# Urban Design Assessment

Council Ref. N/A  
GMU Ref. 12032

Proposed Mixed Use Development at  
**27-31 Belmore Street, Burwood**

November 2012

Figure 1 Suggested design modifications

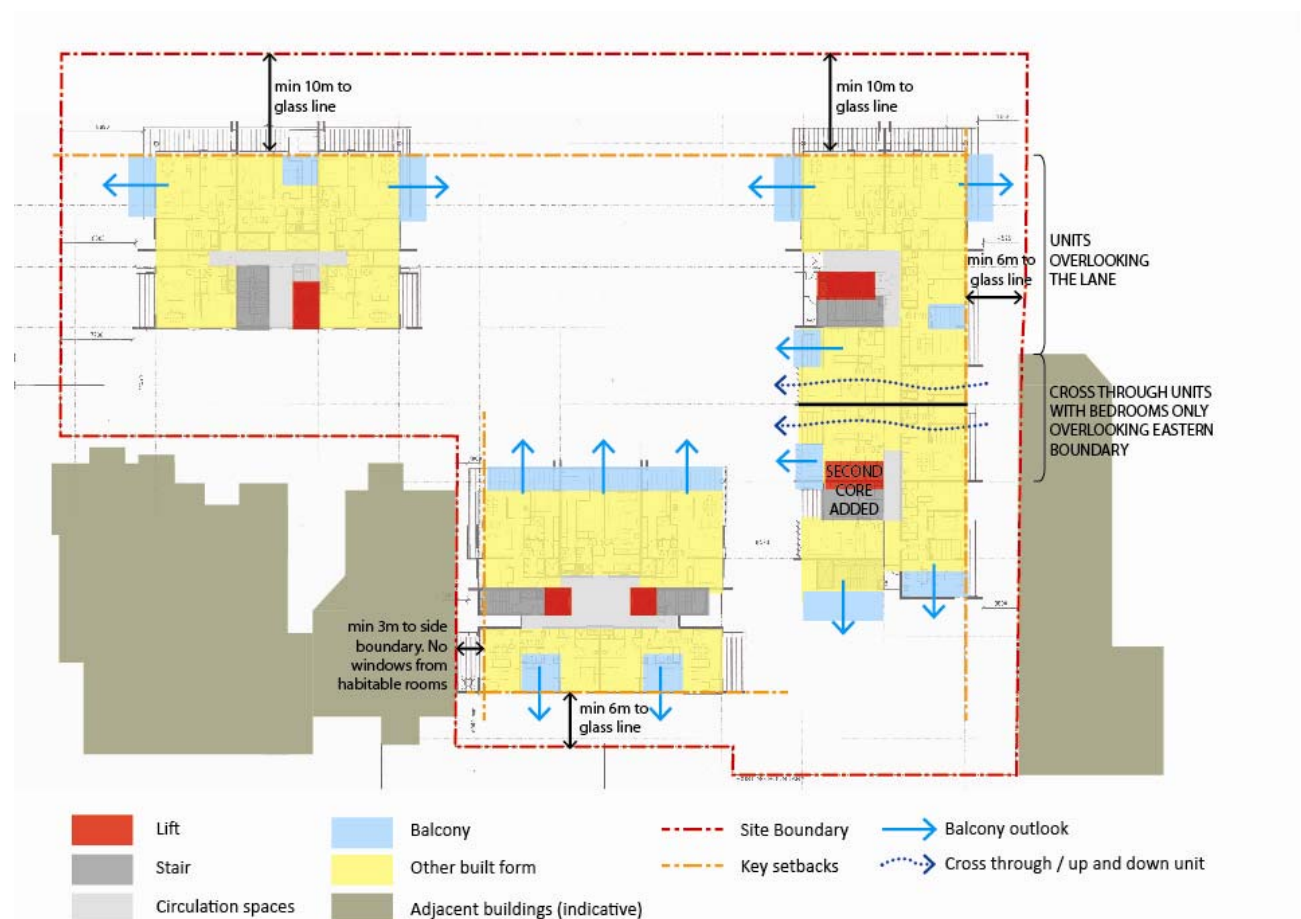
The Applicant has provided a number of justifications as to why these non-compliances should be assessed upon merit; however, it is GMU's opinion that the cumulative effect of all the non-compliances with regards to separation and setbacks will set the wrong precedent for future development in the Burwood CBD, if this proposal were to be approved in its current form. For this proposal to be fully supportable, it is paramount that these issues are better resolved, especially in areas where amenity i.e. privacy, overshadowing and outlook to adjacent and future developments is compromised. The following sketch illustrates a number of suggested design modifications in order to address the issues discussed above with regards to the separation distances.

An explanation of the suggested changes is provided below for each of the towers.

- To be located at least 3m from the western boundary with no habitable windows overlooking the side boundary to 33-35 Belmore Rd.
- Outlooks from balconies and main living areas are to be oriented to the north and south. No balconies to overlook the western boundary.
- Side boundary treatment to be attractive and display design excellence.
- 6m setback to Belmore Street to be maintained throughout the extent of the tower with no private open spaces projecting into the setback.

- Southern units to look to Belmore Street.
- Addition of a second core to allow for cross through units or up and over units that have main living areas oriented to the landscaped courtyard and only bedrooms looking at the side boundary. The building envelope is to provide a 6m setback to the eastern boundary to the glass line with no balconies encroaching on the 6 metres, unless directly overlooking the lane. For the northern units of this tower, an east-west outlook for the private open space is preferred in order to avoid privacy issues with potential development to the north.
- Northern boundary to achieve at least 10m separation to the glass line by redirecting the balconies to the east and west with no private open space projecting into the setback. Living areas can maintain a northerly outlook behind the 10m line.
- North-facing façade to be well articulated.

- Re-orient all proposed balconies looking north to east and west to achieve at least 10m separation distance to the glass line from the northern boundary. North-facing façade to be well articulated.
- All private open space from units that cannot re-orient their private open space are to be contained within the building envelope to achieve a 10m separation from the boundary.

- Reconfiguration of garden units on levels (units 404-406 and 504-506) to the north of the landscaped courtyard to ensure improved solar access to north-facing units on 33-35 Belmore Street for units with a total loss or low percentage of solar access.
